APPENDIX N
NEPTUNE EROSION ANALYSIS
(NEPTUNE, 2021)

Clive DU PA Model—Response to DWMRC 1-28-2021 Comments

5 April 2021

1. Title: Clive DU PA Model—Response to DWMRC 1-28-2021 Comments		
2. Filename: Clive DU PA Model - Response to DWMRC 1-28-2021 Comments.docx		
3. Description: Responses to UDEQ Letter “Technical Report,” dated January 28, 2021.		
	Name	Date
4. Originator	Kelly Crowell, Paul Duffy, and Lauren Foster	5 April 2021
5. Reviewer	Paul Black and Sean McCandless	5 April 2021
6. Remarks

Figure 1. Revised (2021) Federal Cell footprint (from drawing 14004-C01, rev 2).

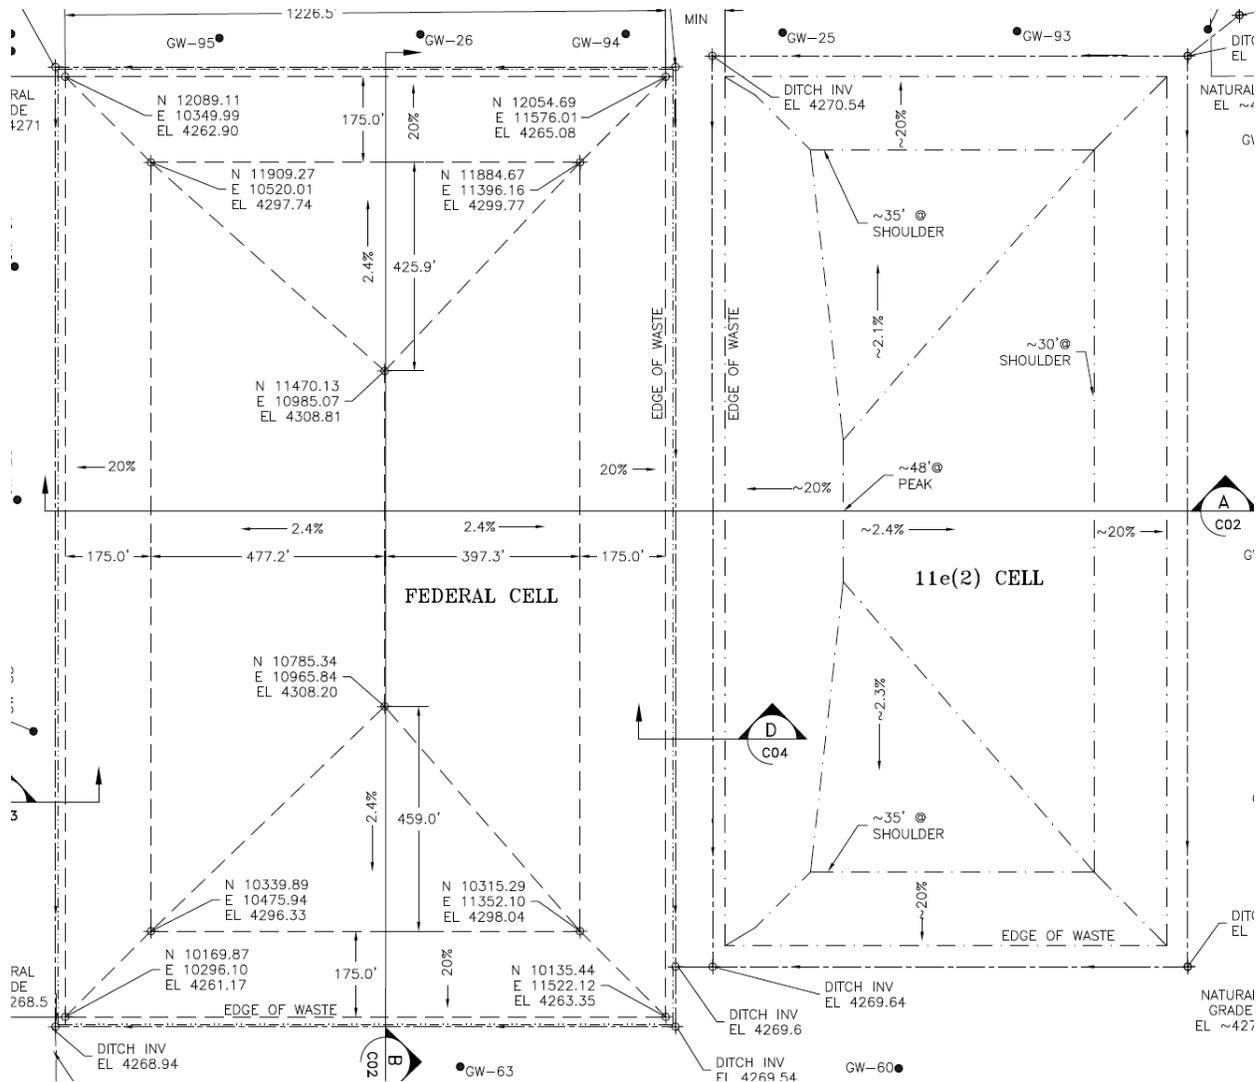
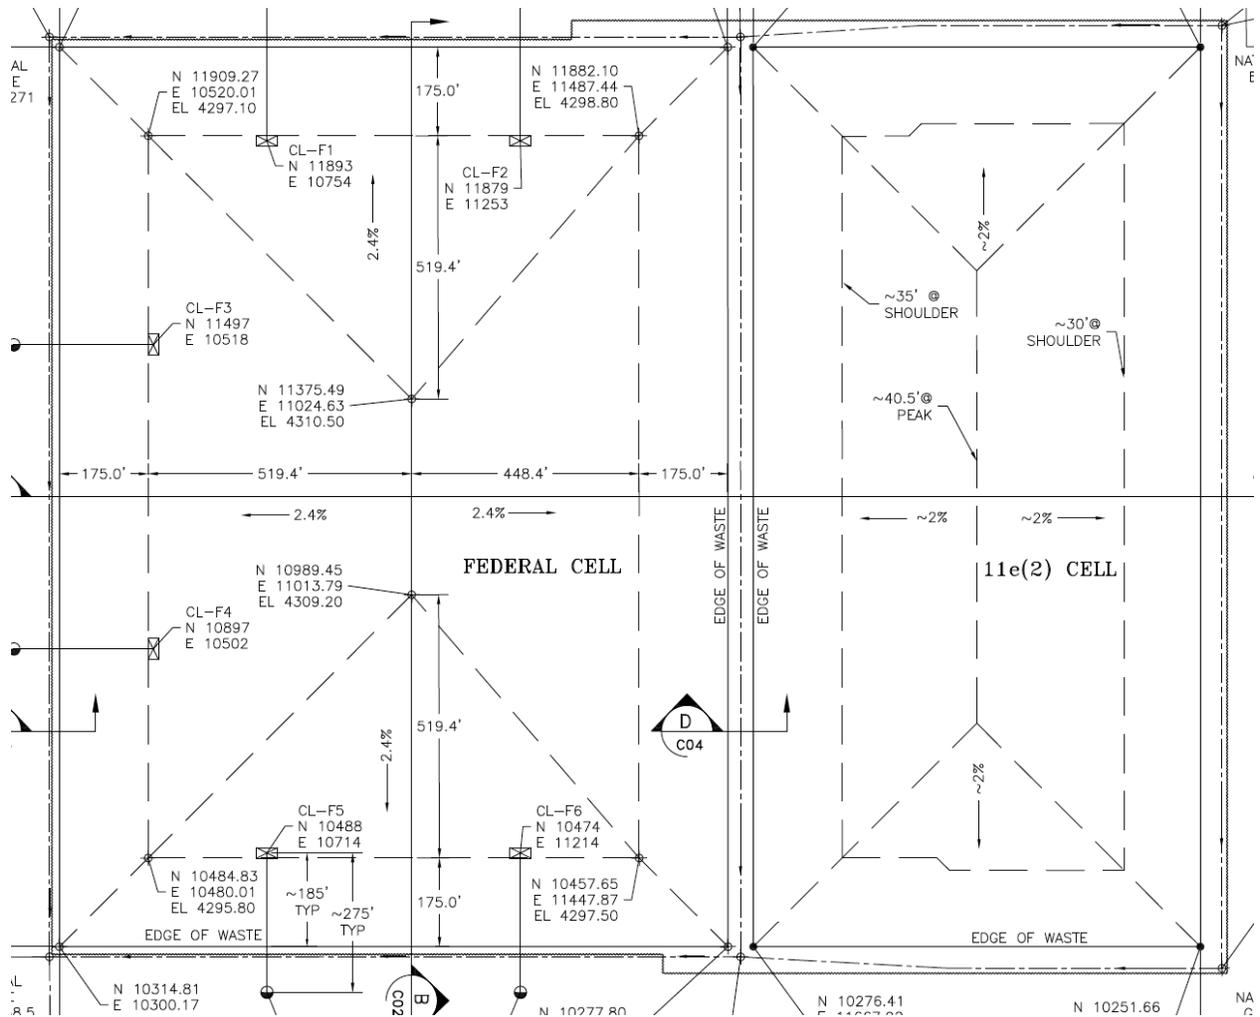
EnergySolutions has revised the embankment footprint in order to provide greater separation between the Federal Cell and the 11e.(2) Cell to the east. The revised footprint is slightly narrower east to west and slightly longer north to south than it was in prior drawings. The grade of the top and side slope areas is unchanged; and the thickness of the cover layers are unchanged from the drawings submitted previously.

The revised embankment footprint has slightly shorter top slope lengths; and a longer embankment crest. Figure 1 shows the revised embankment footprint; Figure 2 shows the version

previously analyzed. Side slope lengths are unchanged. These changes result in a peak embankment elevation at the crest that is one foot lower than that of the previous footprint².

Figure 3. Top Slope Detail (from drawing 14004-C05, rev. 1).

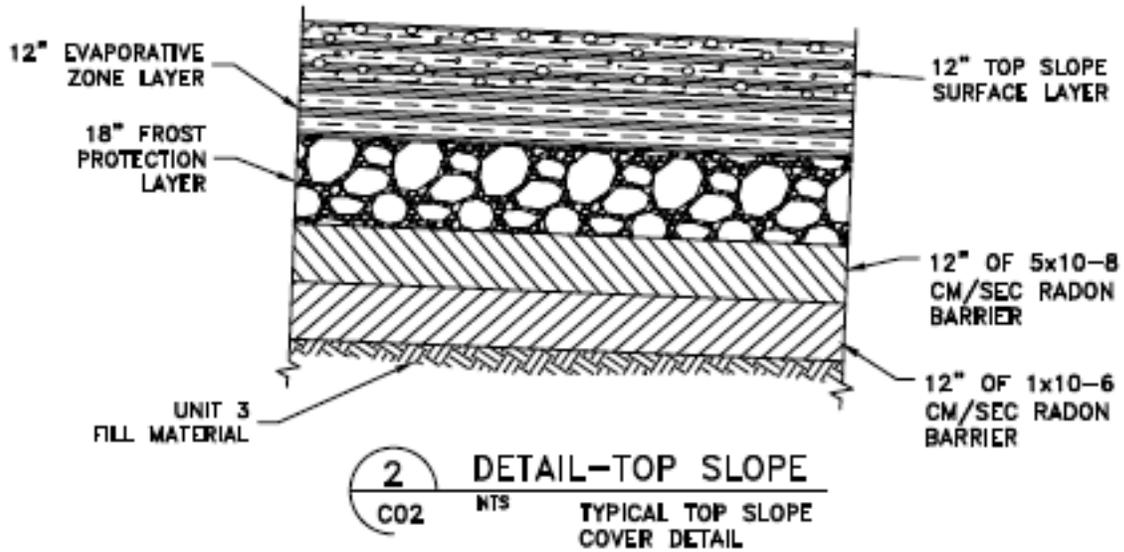
In the 2020 design change to utilize rip rap armoring on the side slopes, the top slope surface layer thickness was increased from 6 inches to 12 inches. This change slightly increases the storage capacity of the ET cover design. SIBERIA-2D evaluation of the full hybrid cover includes this revision. Figure 3 provides the top slope layering.

Figure 4. Transition Zone (2021) Detail (from drawing 14004-C05, rev. 1).

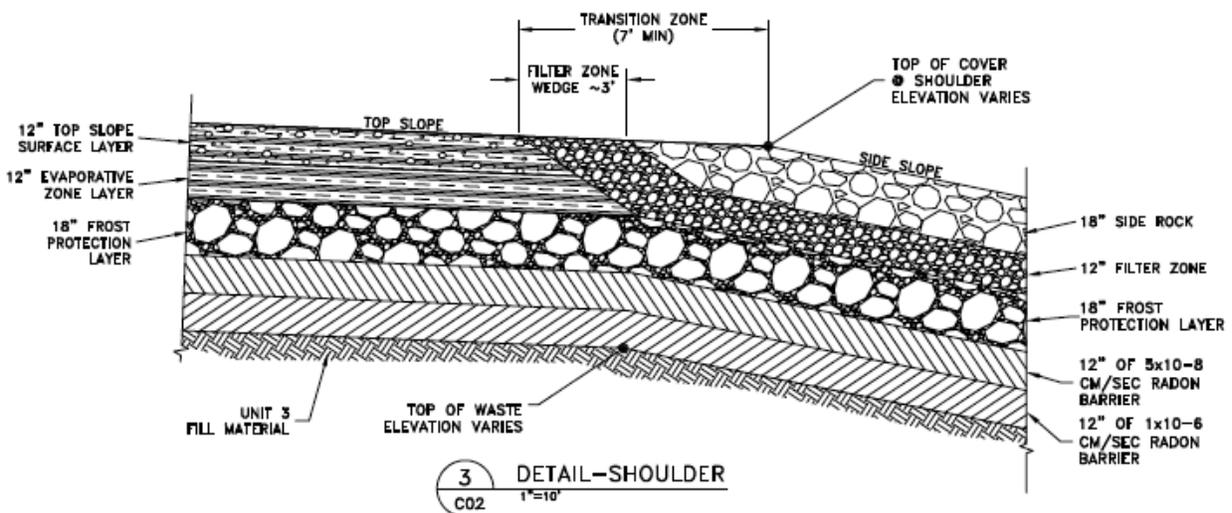
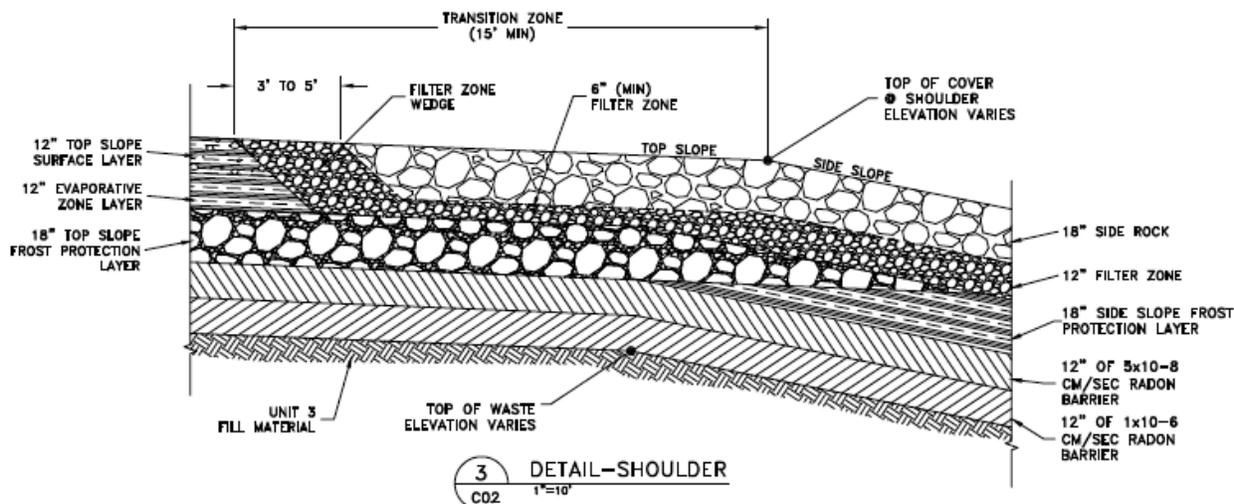
The transition zone revision from the ET cover top slope to the rip rap cover side slope has been revised from that presented in the 2020 design. The revision moves the transition zone to the shoulder of the embankment and reduces its width. These changes were made to reduce the impact of increased infiltration through the rip rap portion of the cover. Figure 4 provides the transition zone detail as currently modeled; Figure 5 displays the prior design.

Concurrent with this change, the material used as the frost protection layer for the side slope has been changed. The current design specifies this material to be the same bank run as used for the frost protection layer on the top slope, where the 2020 design used native clay soils for the side slope. This material was changed in order to ensure consistent drainage properties from the top slope onto the side slope at this layer in the cover system. The change also improves constructability of the transition zone.
